AERONAUTICAL CHARTING FORUM
Instrument Procedures Group
October 29, 2013

FAA Control # 13-02-312

Subject: Equipment Requirement Notes on Instrument Approach Procedures

Fig 1A

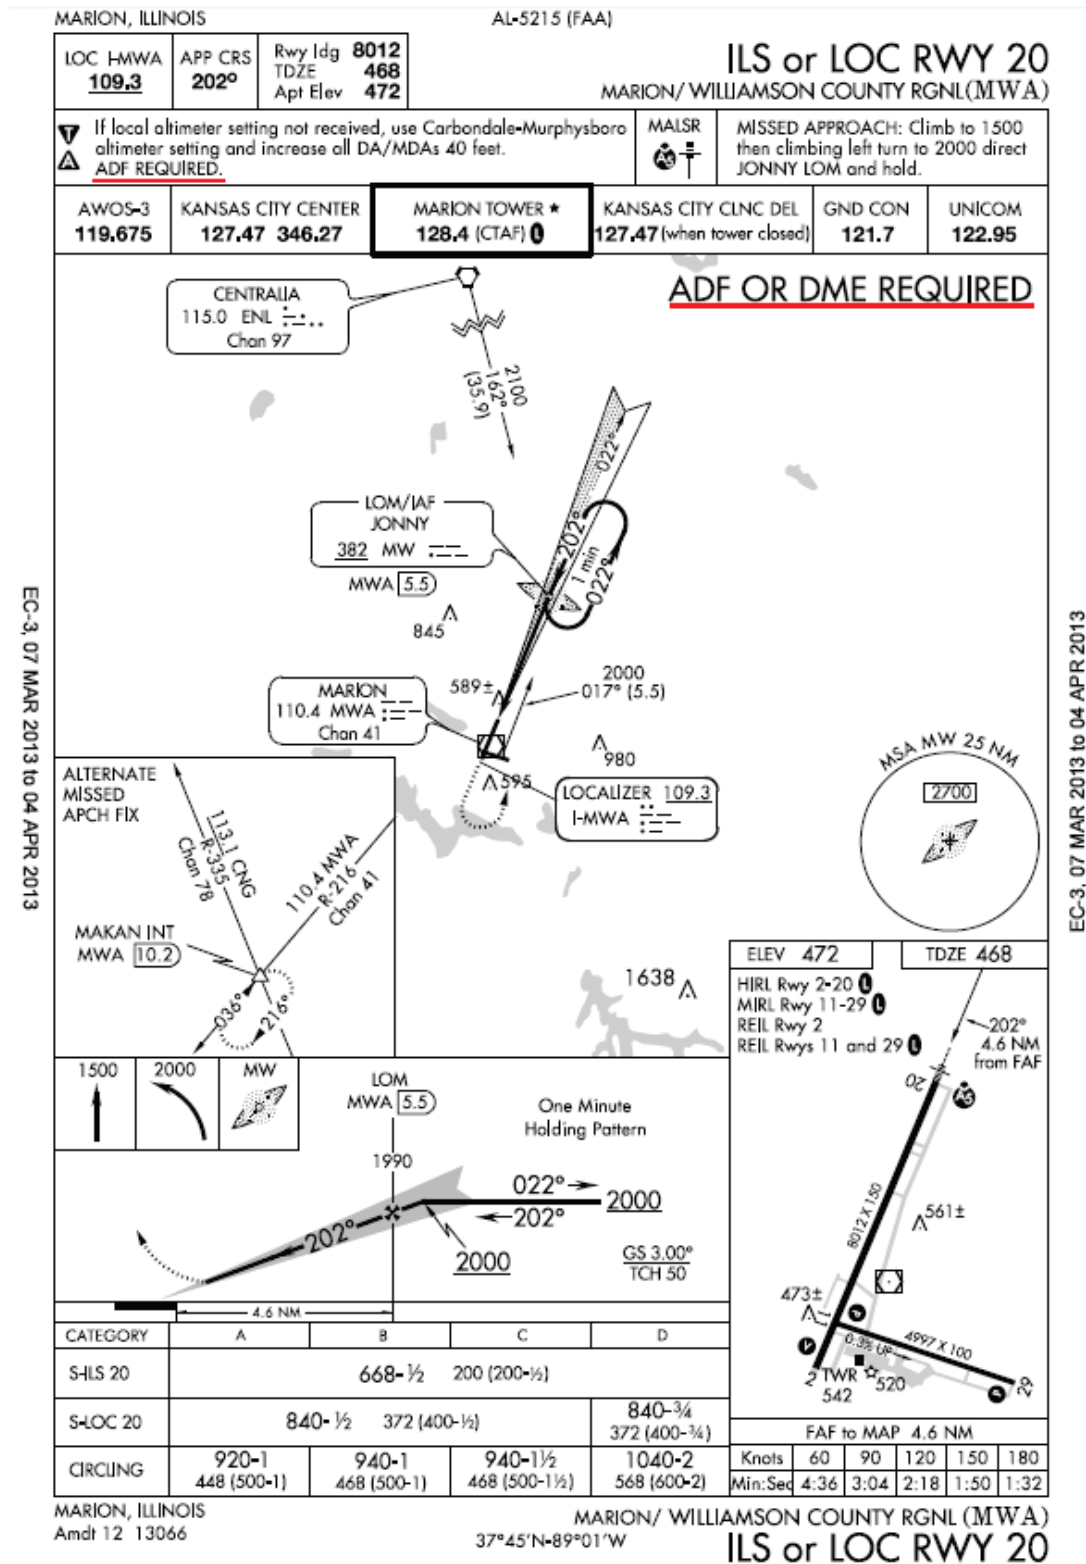
In certain cases, the application of these charting requirements can result in two separate equipment restriction notes on the same instrument approach charts (see Figures 1 and 1A, Marion IL - KMWA, ILS Runway 20). As can be seen on this example, there is a note in the briefing strip notes that states: “ADF Required”. However, in the planview of this same chart there is a note stating: “ADF or DME Required”. These two notes are confusing to the pilot since it is unclear whether ADF is really required, or can DME substitute for the ADF on this approach?” The pilot has no way of determining immediately whether these notes are inclusive of either other (i.e. either ADF or DME is required) or whether they are mutually exclusive of each other (i.e. an ADF is always required).

2. Evaluate all requirements to execute the approach. Determine if any single aircraft equipment or navigation source (e.g. DME, Radar) is required for the approach and publish that requirement on the chart. For example, on the MWA ILS Rwy 20 approach, publish only “ADF Required”. The availability of DME is irrelevant to being able to fly this procedure since ADF is **always** required to fly the procedure.

FIG 2:

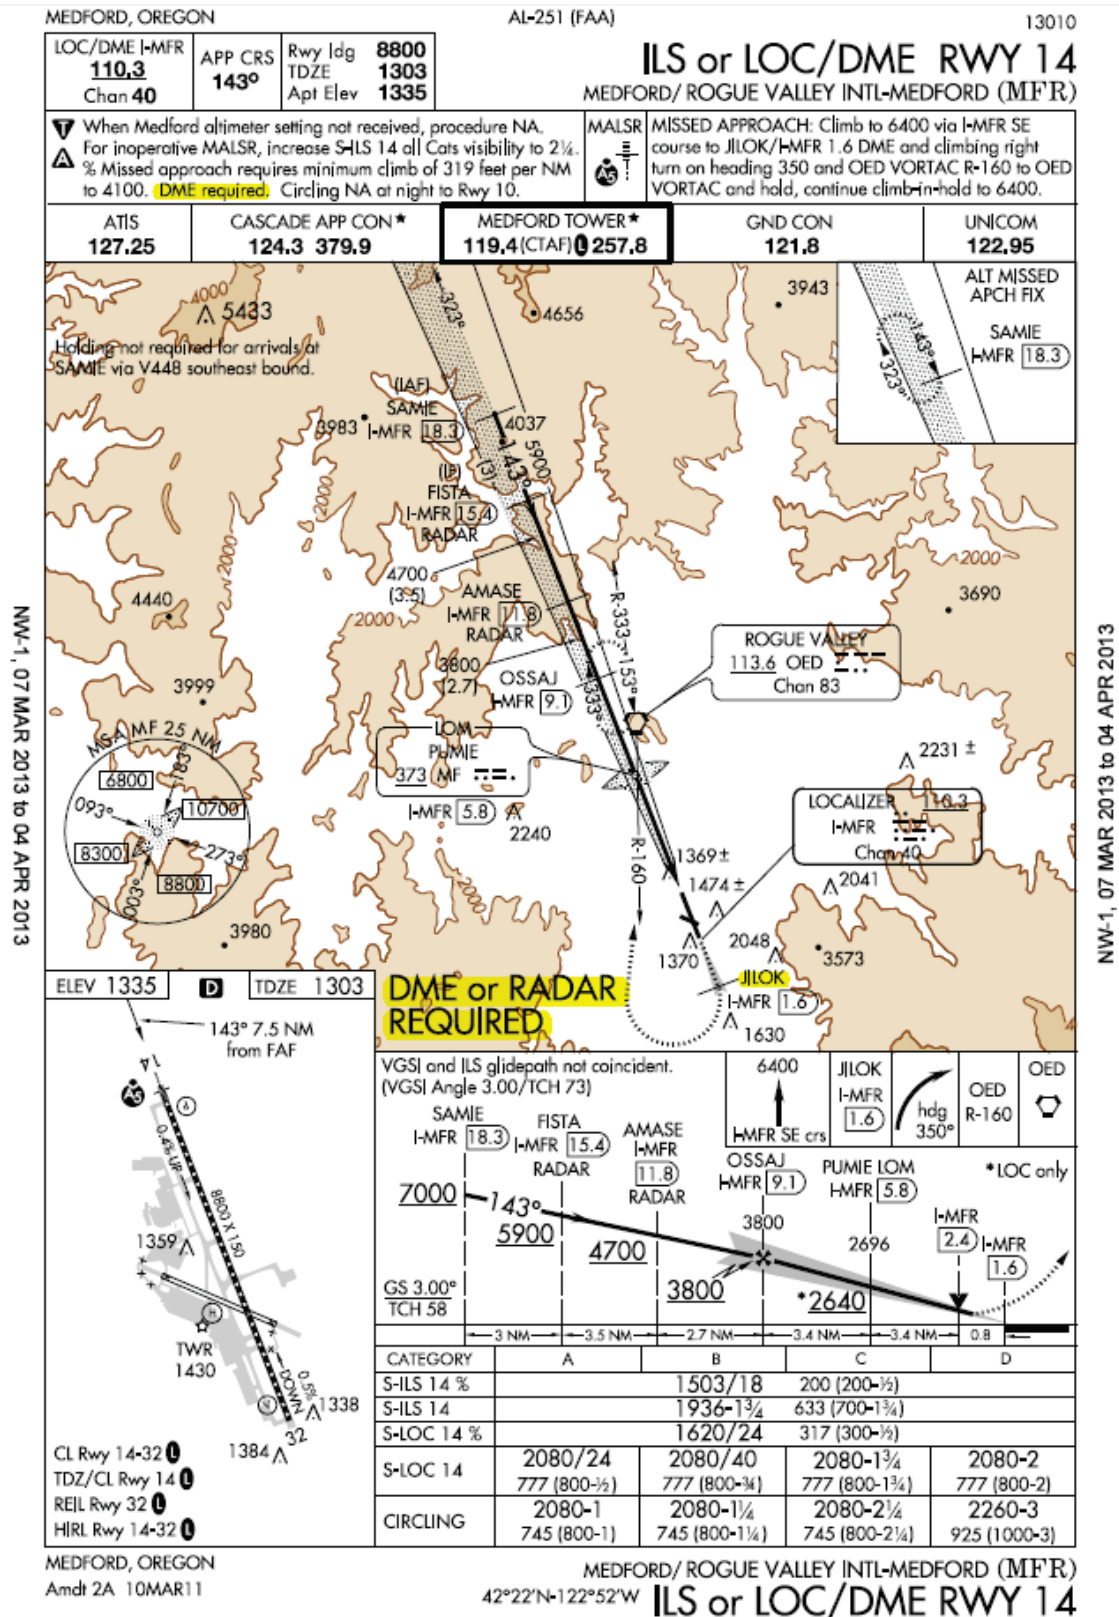
Medford, OR (KMFR) ILS or LOC/DME Runway 14 approach (Fig 2) provides another example of an approach with confusing notes. For this approach, a “DME required” is published in the Briefing Strip because DME is required to fly the missed approach procedure. The planview note, “DME or Radar Required” is published because DME or radar is required for procedure entry.

On a commercially produced version of this same procedure (see Fig 3), a “DME or Radar Required” note is published in the Briefing Strip. Note that this provider publishes the “DME Required” as a minima note associated with the LOC (GS-Out) line of minima. However, DME is required to execute the missed approach segment, regardless of whether the ILS minima or the LOC-only minima are use, and therefore applies to both the ILS and the LOC (GS-Out) lines of minima.
